TVA-BFN-TS-431
TVA-BFN-TS-418

**BROWNS FERRY NUCLEAR PLANT (BFN) - UNITS 1, 2, AND 3 -
TECHNICAL SPECIFICATIONS (TS) CHANGES TS-431 AND TS-418 -
EXTENDED POWER UPRATE (EPU) - RESPONSE TO PRELIMINARY
FINDINGS ON STEAM DRYER STRESS ANALYSIS**

TECHNICAL SPECIFICATIONS (TS) CHANGES TS-431 AND TS-418 -
EXTENDED POWER UPRATE (EPU) - STEAM DRYER ANALYSIS REVIEW
RESPONSE TO PRELIMINARY FINDINGS ON STEAM DRYER STRESS ANALYSIS
(NON-PROPRIETARY VERSION)

Figure EMEB.124/91-1
Acoustic Vibration Suppressor

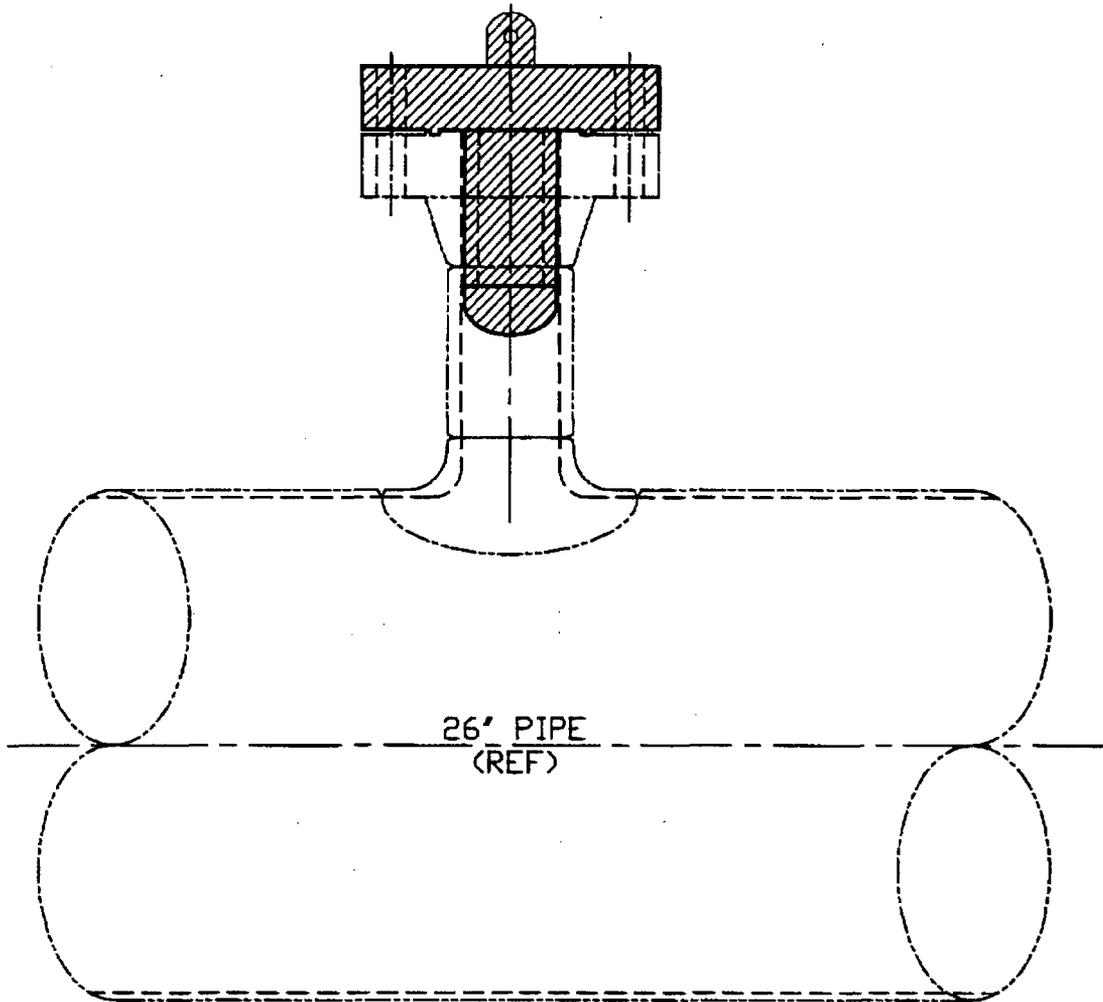
In Table 8B of Continuum Dynamics Incorporated (CDI) reports 7-05P and 07-06P (Enclosures 1 and 2 of the July 27, 2007, letter), TVA reports the minimum stress ratio at current licensed thermal power (CLTP) of 0.96 for Unit 1 and 0.49 for Units 2 and 3. These low ratios (< 1.0) imply that the maximum stress of the BFN steam dryers exceeds the fatigue limit at CLTP for the current plant configuration. TVA indicated in Section 5.3 that the high stress was due to a strong pressure peak identified at 218 Hz. This peak was filtered out of applied time history to dramatically reduce the stresses shown in Table 9B where the minimum stress ratios are all greater than 1.0. TVA indicated that the elimination of 218 Hz peaks can be achieved by plugging eight unused standpipes in main steam lines (MSLs) 'A' and 'D', and four in MSLs 'B' and 'C'. TVA is requested to demonstrate that the plugging of these standpipes eliminates the 218 Hz peak.

In order to mitigate the most limiting component of steam dryer cyclic stress calculated at CLTP conditions in CDI reports 07-05P and 07-06P, Browns Ferry plans to install acoustic vibration suppressors (AVSs) in the eight unused safety relief valve (SRV) standpipe locations on the main steam lines (MSL) which are in the flow stream. The standpipes in the flow stream are located on MSLs A and D only. MSLs B and C have four similar standpipes which are located in dead legs outside the flow stream and would not contribute to the 218 Hz peaks.

Based on this investigation, TVA has concluded that the unused SRV standpipes are a significant source of acoustic loading. As such, TVA plans to directly address dryer loading by eliminating the standpipes as a source of excitation. The approach being taken to eliminate the 218 Hz resonance in MSLs A and D is to increase the fundamental acoustic resonant frequencies (i.e., quarter-wave frequencies) of the standpipes by decreasing their effective lengths through the installation of AVSs, so that resonance due to vortex shedding will not occur at main steam flow rates up through EPU conditions. Accordingly, AVS devices will be installed in the eight standpipes in MSLs A and D which are in the flow stream. AVS devices will not be installed in the four unused standpipes on MSLs B and C because these branches are located on the dead-leg portion of the line and are not exposed

to main steam flow. Figure EMEB.124/91-1 is a sketch showing the design of the AVS. An AVS design was performed which includes sensitivity analyses to demonstrate that the fundamental acoustic resonant frequencies of the modified standpipe configurations are sufficiently increased to avoid resonance at all flow rates up through EPU.
